Wiltshire Council Planning Consultation Response

URBAN DESIGN

Application No: PL/2023/07797
Proposal: Reserved Matters Application pursuant of Outline Permission 19/05898/OUT (Outline application for up to 50 residential units, internal road, parking, open space and associated works, with all matters reserved other than access) relating to Appearance, Landscaping, Layout and Scale.
Site Address: Land off Park Road Malmesbury
Case Officer: James Repper

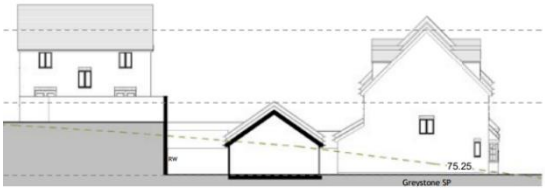
The Layout also creates a visually awkward expanse of hardstanding with the squaring off to the outer side of the right angle bend in the street in front of plot 33, encouraging pedestrians to short cut into the road at this point and drawing emphasis to the parking stub ahead rather than the street/pavement attractively following round as on the Site Layout on 19/05898/OUT.

X Addressed but house 29 can only be accessed by surfaced path across parking bay between cars in bays which is a poor level of amenity - in conjunction with above matter path should connect up either side-with path and communal drive.

Meant 27/ 28 -i.e. simply extend path across front of 26 to connect up with path in front of bays P27,28 and extend through to communal drive

This street would also appear to be the vehicle means of access and road continuation into a potential significant extent of future development within the large expanse of remaining field open space beyond which would not be a welcoming route for pedestrians on this desire line in proximity, interacting with manoeuvring and informally parked vehicles which the similar access on Site Layout to 19/05898/OUT avoided end on parking along this street.

X Still the case - re my first paragraph in this point 3
√ Satisfactorily addressed on Site Layout Plan D5 -P4

Above: Extract from : Revised street scene elevations AA (plot 1 right hand end). and from revised Section (now labelled Site section 1) .

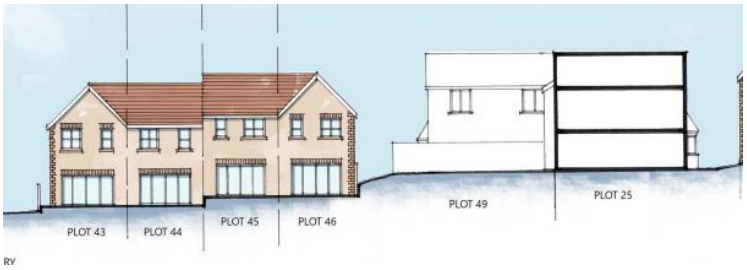
4) The Street scene Elevations (1-1 and A-A -extract below) indicate that the gable end of house 8 would appear overbearing and oppressive on the rear gardens and outlook from the plots notably from houses 1 and 2 in this proximity. A high timber fence proposed along the house 8 and the courtyard boundary with rear of plots 1 to 4 would not be suitably robust to maintain a lasting appearance and longevity and I question the soundness of topping the retaining wall with such an insubstantial structure given the considerable drop off from a vehicle manoeuvring area.

This would not appear a sensitive response to local topography and townscape characteristic of the town required by MNP Task 8.20 where such buildings would typically step up the slope in the street scene (as the 19/05898/OUT appropriately indicated with the housing as a stepped terrace

following up the slope.) or split level to accommodate this slope rather than plots cut deeply into this steep slope.

X These revised drawings indicate this would still be oppressive and overbearing extent. The 'Site sections' on drawing DR A (05)101 on 19/05898 /OUT (extract below) showed how the houses in this area of the site could comfortably follow up the slope . A similar layout is necessary for this end of the site to achieve this.
